SERVICE INFORMATION NO. SI36-045

ATA Code: 34-00
GARMIN Software Service Bulletin Nr. 0730
Revision A

SOFTWARE SERVICE BULLETIN

SUBJECT: GTX 330/330D, GTX 33/33D, and GTX 328 Software Version 5.01
available for non-G1000 applications only

Figure 1

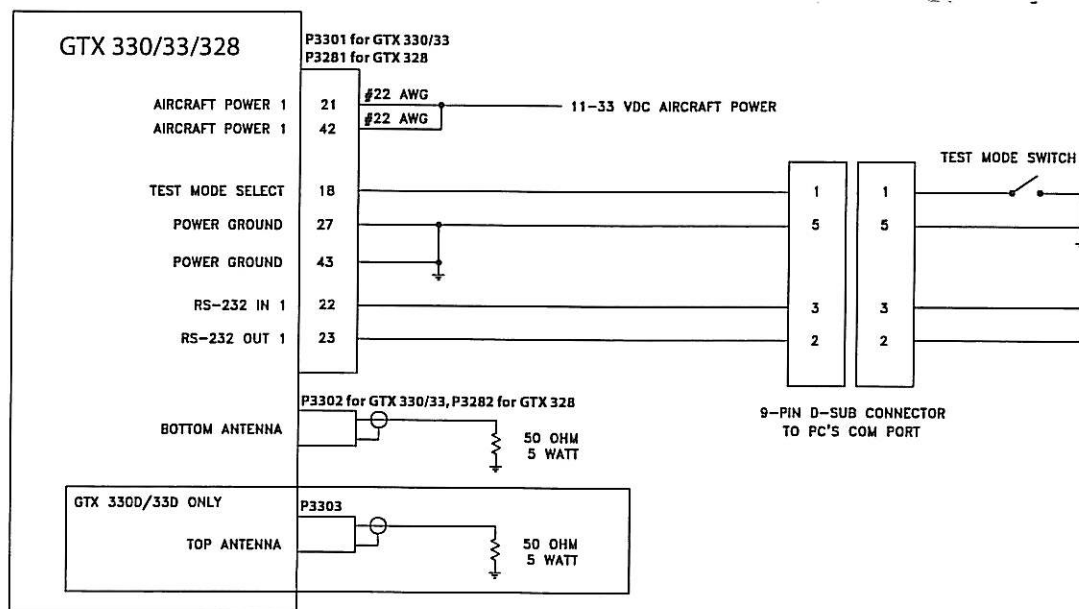
1. Use a test harness for the GTX 330/GTX 33/GTX 328 as shown in Figure 1.

If the unit is removed from the aircraft and operated, always connect J3302 for GTX 330/33 (and J3303 for GTX 330D/GTX 33D) or J3282 for GTX 328 units, to an antenna or a 50 Ω , 5-watt load. The GTX 330/GTX 33/GTX 328 transmits Mode S acquisition squitter replies once per second whether interrogations are received or not. Failure to connect a dummy load during this procedure will cause the transponder to fail.
